August 7, 2023
AVO 37449

Re: Dollar General Final Plat and Construction Plans
First Review

The City of Sanger requested Halff Associates, Inc. review the Dollar General Final Plat and Construction Plans prepared by Triangle Engineering LLC. dated June 21, 2023. We have completed our review and have the following comments:

GRADING PLAN
DOLLAR GENERAL
NE QUADRANT OF FM 2450 & CHAPMAN ROAD
CITY OF SANGER ETJ
DENTON COUNTY, TEXAS 76266
JAMES B.P. JANUARY SURVEY ABSTRACT NO # 658

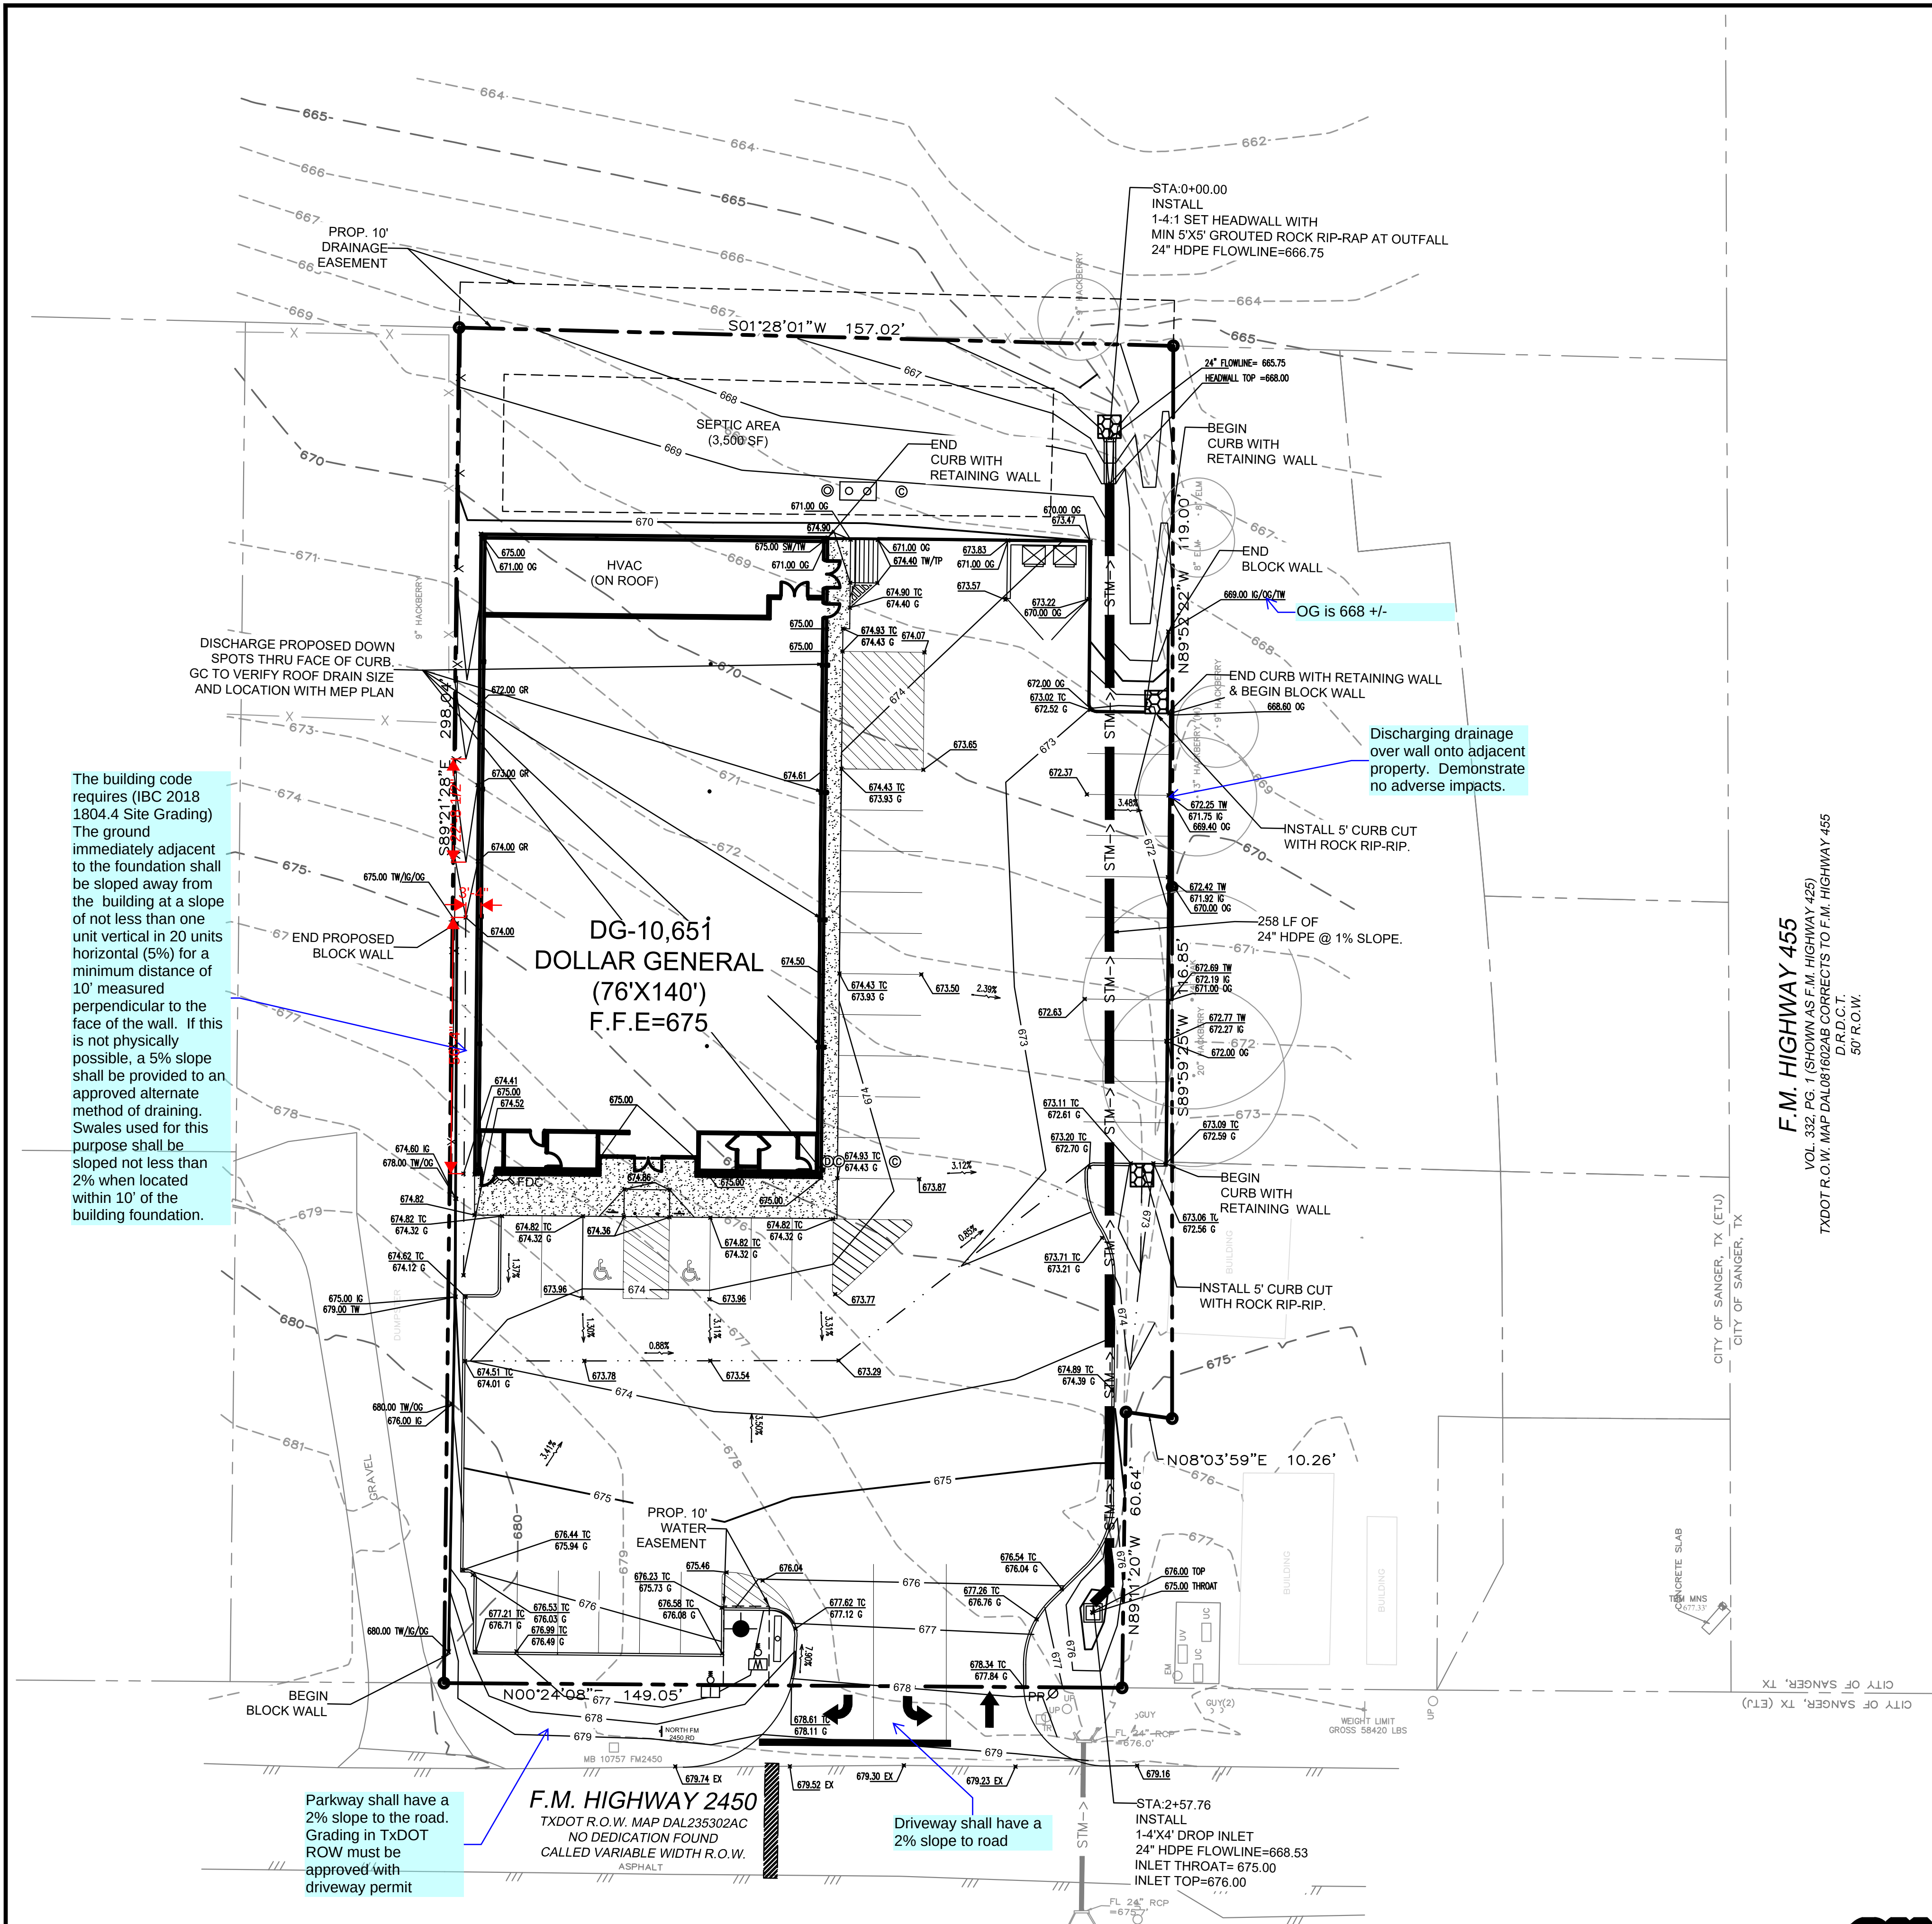
10. The building code requires (IBC 2018 1804.4 Site Grading) The ground immediately adjacent to the foundation shall be sloped away from the building at a slope of not less than one unit vertical in 20 units horizontal (5%) for a minimum distance of 10' measured perpendicular to the face of the wall. If this is not physically possible, a 5% slope shall be provided to an approved alternate method of draining. Swales used for this purpose shall be sloped not less than 2% when located within 10' of the building foundation. Confirm grading on north side of building.

11. Parkway and driveway shall have a 2% slope to the road. Grading in TxDOT right of way must be approved with driveway permit.
12. Grading plan discharges surface drainage over the wall on the south side of the site. Consider regrading the area to drain east, add an inlet, or demonstrate no adverse impact for discharge.

13. Confirm south retaining wall original grade elevation.

The building code requires (IBC 2018 1804.4 Site Grading) The ground immediately adjacent to the foundation shall be sloped away from the building at a slope of not less than one unit vertical in 20 units horizontal (5%) for a minimum distance of 10' measured perpendicular to the face of the wall. If this is not physically possible, a 5% slope shall be provided to an approved alternate method of draining. Swales used for this purpose shall be sloped not less than 2% when located within 10' of the building foundation.

EROSION CONTROL PLAN

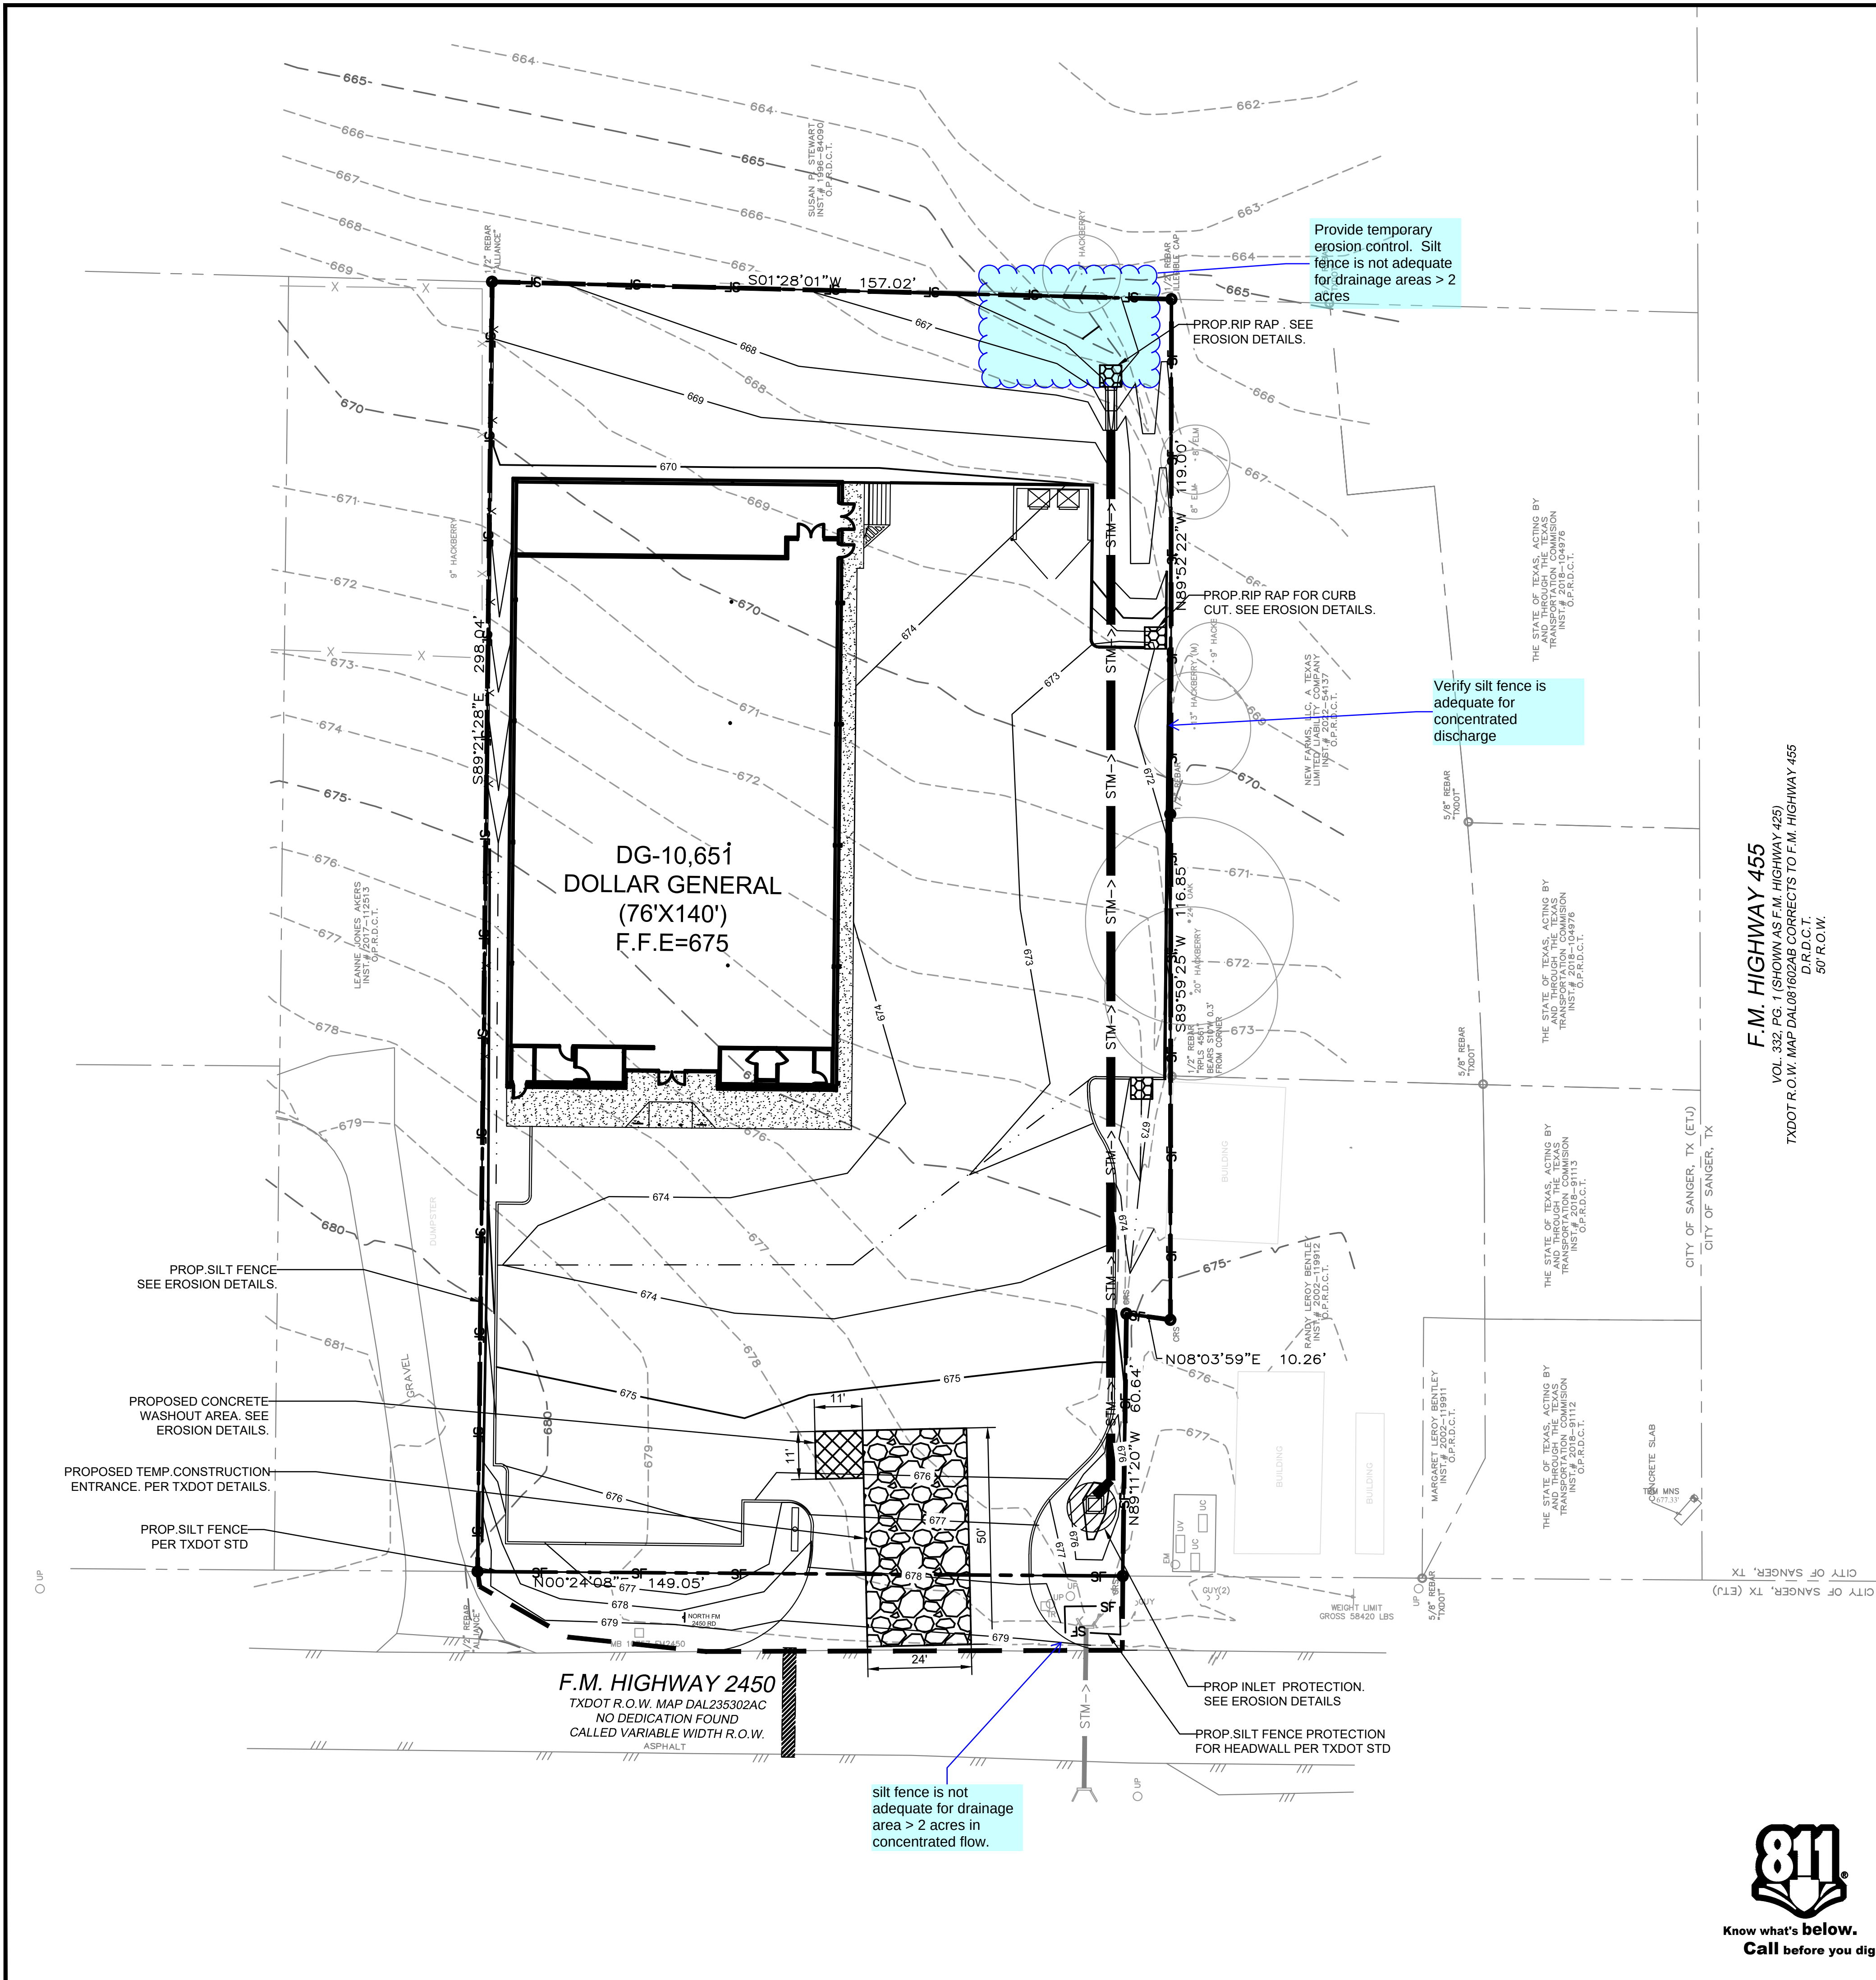
14. Provide erosion control on east discharge point and west incommoding point adequate for designed discharge. Silt fence is not adequate for areas greater than 2 acres.
